**Addendum #1  
Request for Bids (RFB) 2023-05  
Isle of Palms Marina – Public Dock and Intracoastal Dock Improvements  
November 10, 2023**

This addendum is intended to provide further clarification to the Bid Documents for this project, dated October 19, 2023.

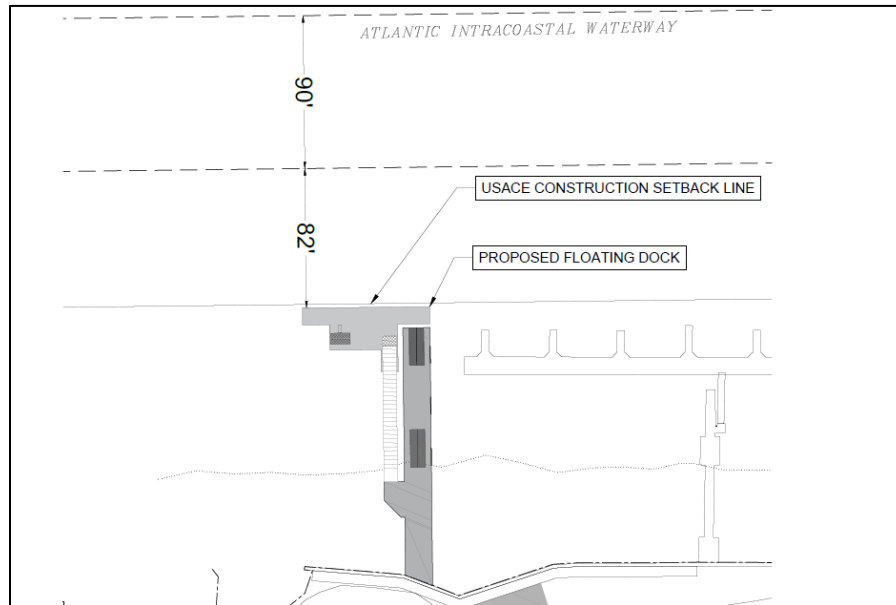
- Public Dock support/foundation piling shall be 13" butt diameter with a consistent taper not exceeding 0.1 inch/foot in accordance with ASTM D25.
- See below image for the channel offset from the proposed floating dock at the new Public Dock.

As is seen, the proposed floating dock is approximately 80-ft. from the edge of the authorized channel in this area.

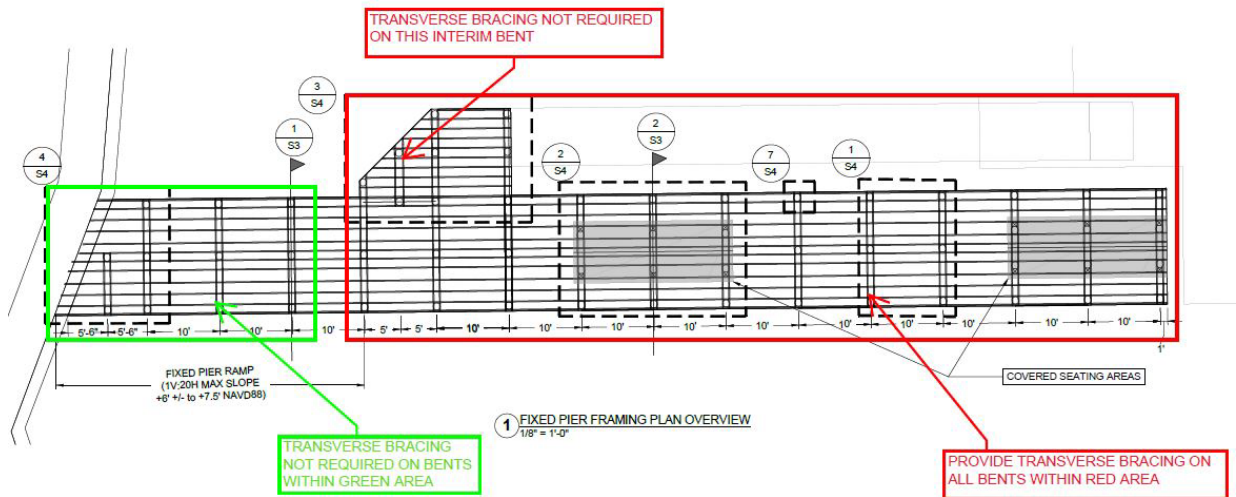
- Due to marsh elevation and tie elevation of the new fixed pier to the existing boardwalk, what bent does the transverse x-bracing begin?

**Provide transverse cross bracing at each bent beginning at the fifth (5<sup>th</sup>) bent from shore as illustrated below.**

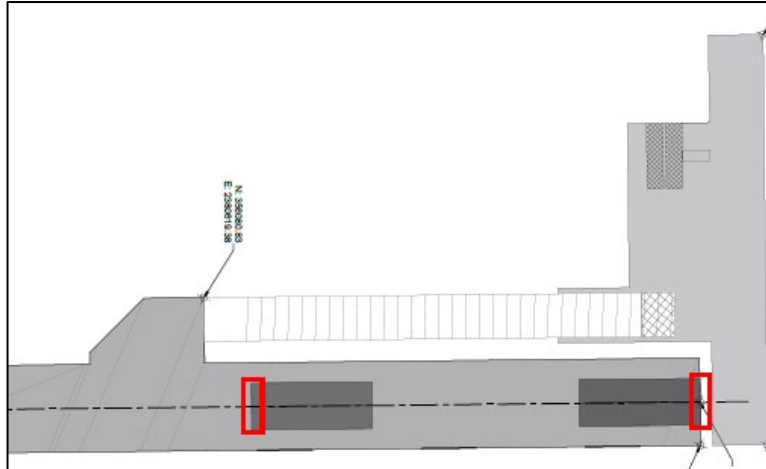
- On drawing S6...
  - Does the City Seal go on both sides of both covered roofs?

**Provide signs in the two (2) locations illustrated below.**

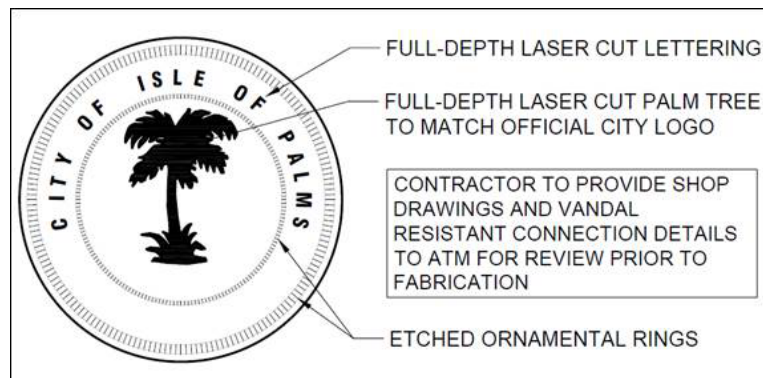
- Can you provide more details for this 18" diameter City Seal?

See below.

**No. The seal is intended to be a flat plate (thickness to be determined by the Contractor and their fabricator) with full-depth laser cut lettering and palm tree. Ornamental concentric rings shall be etched into the outer surface of the plate.**

**Note: Contractor shall provide details of proposed cutouts and etchings with their shop drawing submittal after contract award and prior to fabrication.**

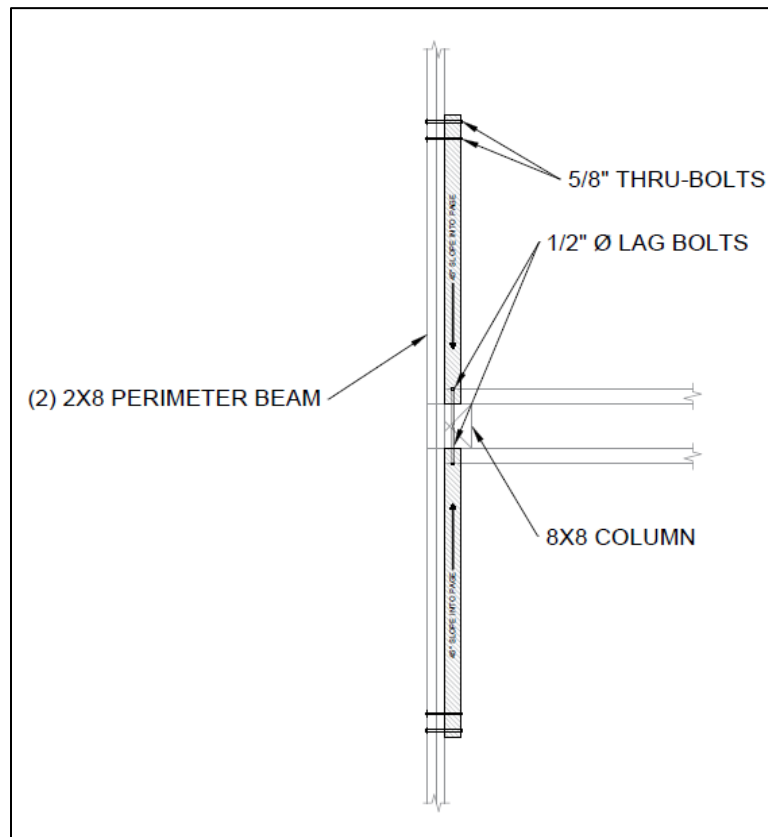
- On drawing S6...
  - Detail 2 shows transverse 2x6 braces from the 3x8 girders to the 8x8 columns. A 2x6 doesn't seem wide enough to accept a 1/2" lag bolt for the connection to the 8x8 column. Please confirm that the braces are to be 2x6.

**The braces should be 3X6 as opposed to 2X6 currently shown on the plans.**

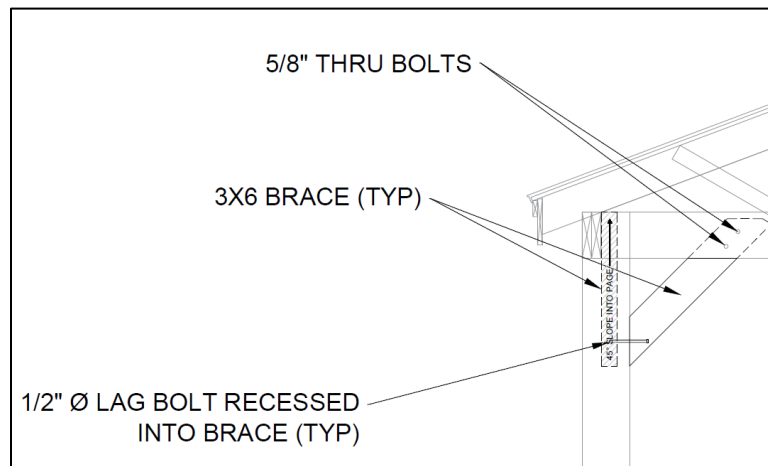
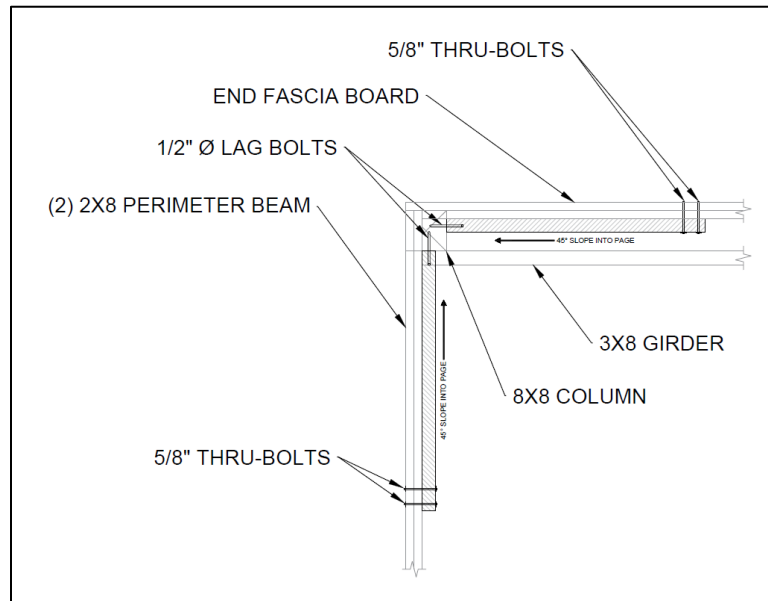
- Also, is it (2) 2x6 braces per 8x8 column? The way the 2x6 attaches to the 3x8 girder it will put the other end of the 2x6 brace very close to the edge of the 8x8 column. Please confirm these details.

- On detail 1 it shows braces in the longitudinal direction too but there are no other details to support this. Please provide clarifications for this.

**No transverse bracing is required at the center column line (i.e., braces are only required around the perimeter of the roof structure). See figures below.**

**See figures below as well as Detail 1 on Sheet S7.**

DRAWING NUMBER  
**M1**

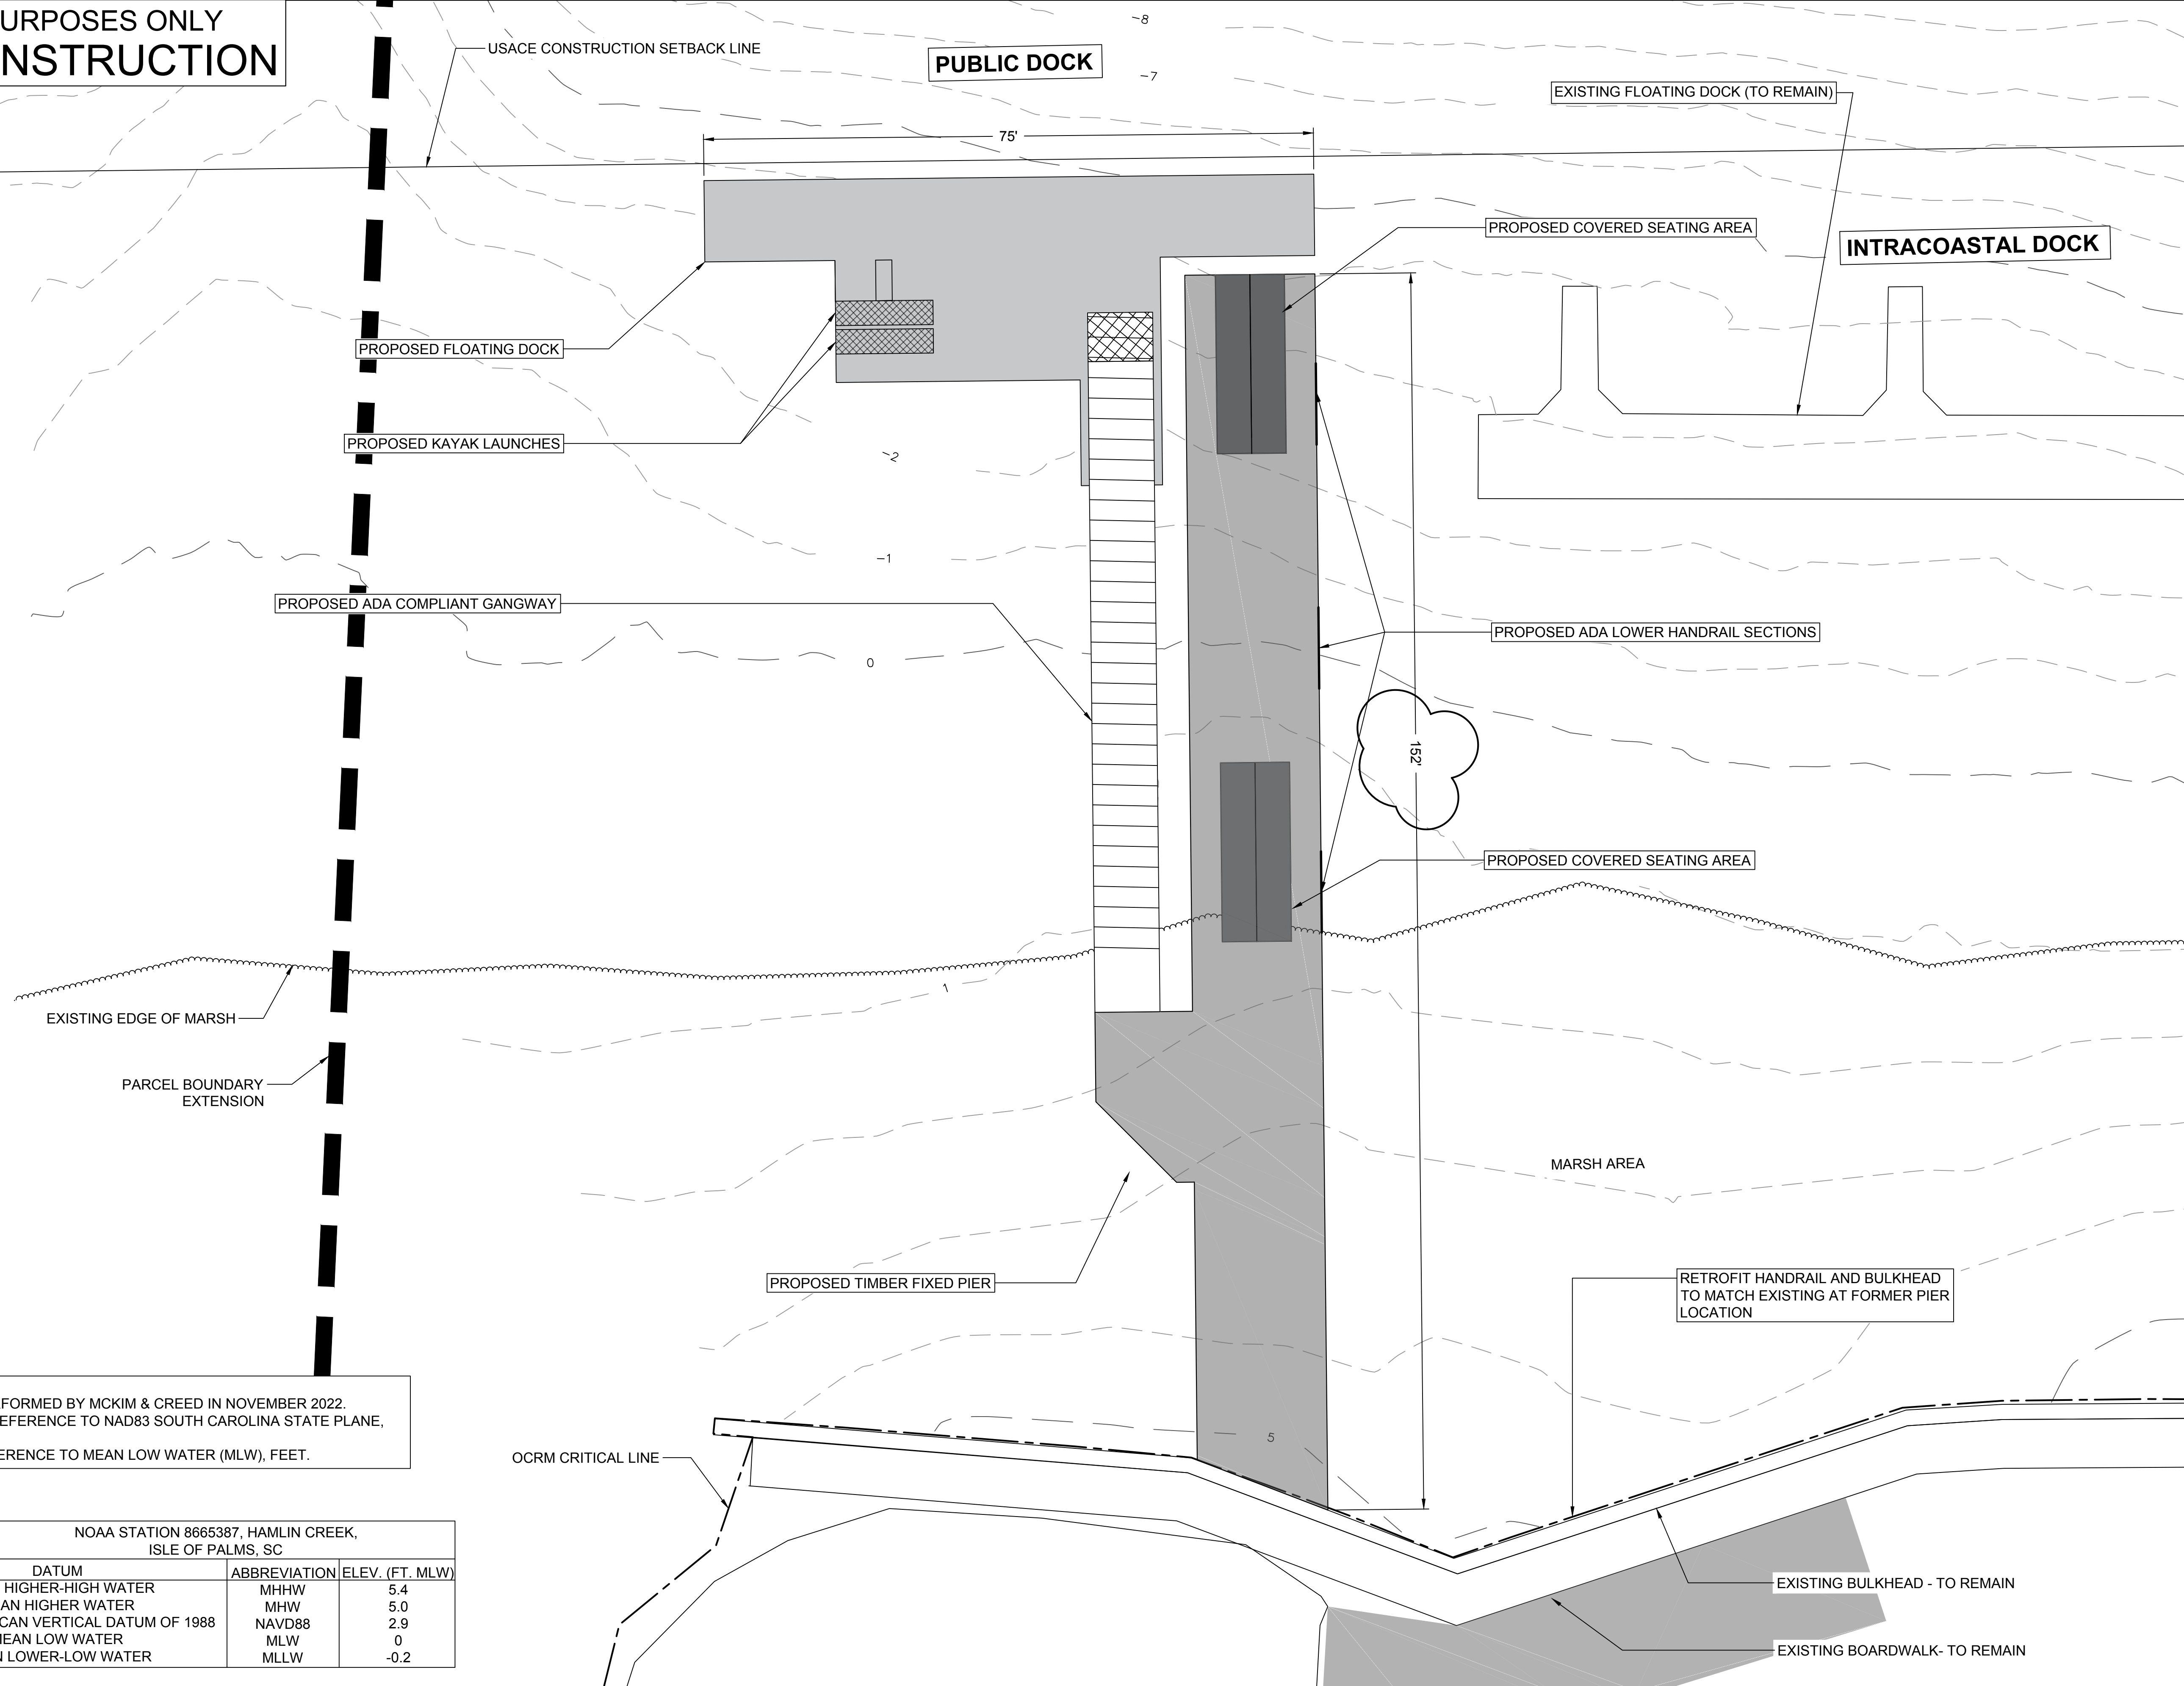
- A dimensioning error was pointed out on plan page M1. That plan page has been corrected and is attached hereto for reference/use.
- Regarding insurance, Professional Liability coverage as specified will have to be provided by the Contractor's selected design engineer(s) for the floating dock, gangway, and floating dock anchorage portions of the project.

DRAWING NUMBER  
**E2**

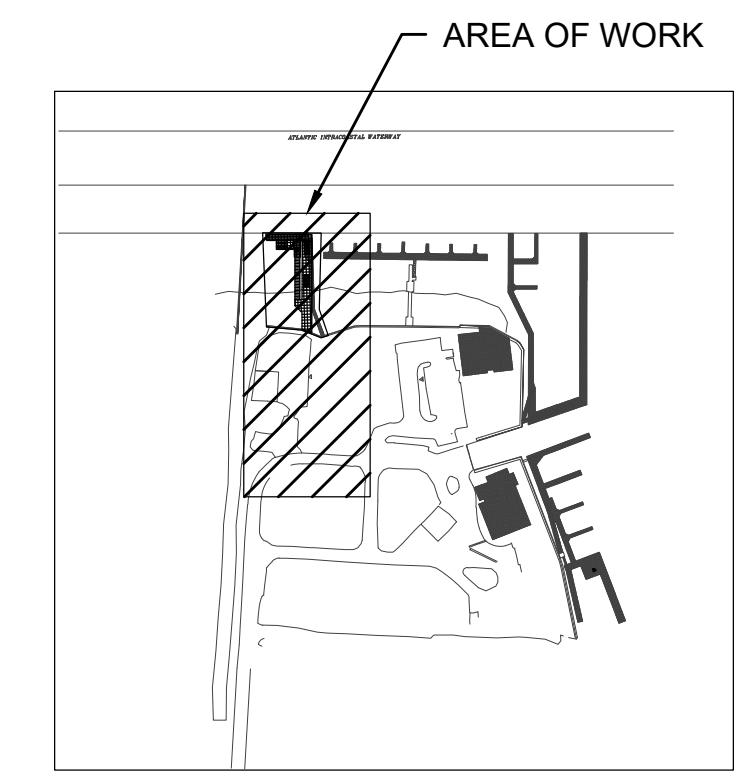
- Location of the electrical feeder to the dock area was discussed briefly and Mr. Tempel pointed out that plan page E2 (note 4) contains a bid alternate to provide additional

underground feeder if the existing feeder cannot be located. Please refer to revised Plan Page E2 and Bid Form (both attached).

4. CONTRACTOR TO LOCATE EXISTING FEEDER CONDUCTORS TO KWH METER. VERIFY WIRE SIZE AND AMPACITY. REUSE CABLE AS AVAILABLE. THE POWER COMPANY DOES NOT ALLOW HANDHOLES OR PULL BOXES ON UNMETERED FEEDER CONDUCTORS. PROVIDE BID ALTERNATE TO PROVIDE AND INSTALL APPROXIMATELY 200' OF 3#4/0, 1#10G, 3" C UNDERGROUND FEEDER. INCLUDE TRENCHING, CUTTING AND PATCHING IN BID.
